APPLICATION FOR SOIL INVESTIGATION

APPENDIX H
SITE EVALUATION

SITE INVESTIGATION REPORT
INDIVIDUAL SEPTIC TANK SYSTEM
WITH SUBSURFACE,
SOIL ABSORPTION,
EFFLUENT DISCHARGE

SIR.NO. 15056
T.C.HO. po 105-153-07
MAP DATE
DATE February 16, 1979

* See Diagram on Back (Include: Soil areas, property lines, roads, streams, gullies, wet areas, fill areas, wells, water bodies, slope patterns)

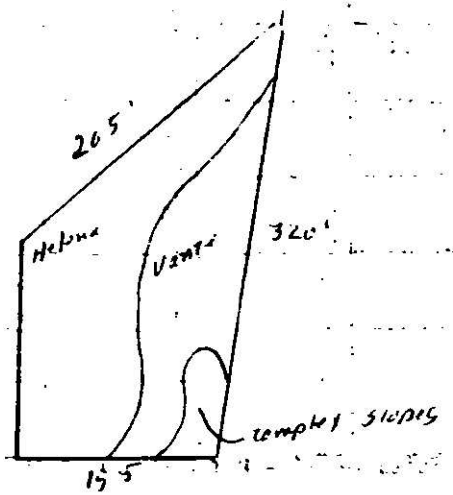
FACTORS	AREA 1	AREA 2	AREA 3	AREA 4
1. SLOPE (%)	(S) PS U 2 to 6%	(S) PS U 2-8%	S complex PS slopes (U)	S PS U
2. SOIL TEXTURE (12-36 in.) (Sandy, loamy, clayey, Note 2:1, Clay)	S 2-1 PS clay (U)	S 2-1 PS (U) clay	S 2-1 PS clay (U)	S PS U

3. SOIL STRUCTURE (12-36 in.) (Clayey Soils) ✓	S Massive PS (U)	S (PS) Blocky U	S (PS) Blocky U	S PS U
4. SOIL DEPTH (In.)	(S) 48" PS U	(S) 48" PS U	S Depth PS Variable (U)	S PS U

5. RESTRICTIVE HORIZONS (In.) (Impervious Strata, Rock)	(S) None PS U	(S) None PS U	(S) None PS U	S PS U
6. SOIL DRAINAGE/GROUNDWATER (External & Internal)	S Seasonal PS Perched (U) water table	(S) To seasonal PS ground U water	S Eroded PS Areas (U) Normal water	S PS U

7. SOIL PERMEABILITY (Percolation Rate) ✓	S PS (U) Slow to slow	S Slow PS (U)	S Slow PS (U)	S PS U
8. OTHER (Specify)	S PS U	S PS U	S PS U	S PS U
9. SITE CLASSIFICATION ✓	Unsuitable	Unsuitable	Unsuitable	
SOIL SERIES	Helena	Davidson	Eroded Area

Diversion Ditch constructed

Soil Structure Massive
Soil Permeability Unsuitable
Site Classification Unsuitable

Sites classified as Unsuitable are not acceptable for soil absorption of sewage effluent. However, if engineering, geologic, soil, and environmental studies indicate that a suitable septic tank system or a suitable alternate system can be expected to function satisfactorily, such sites may be re-classified as Provisionally Suitable. (Section 10 of the North Carolina Administrative Code 10 A,.1910)
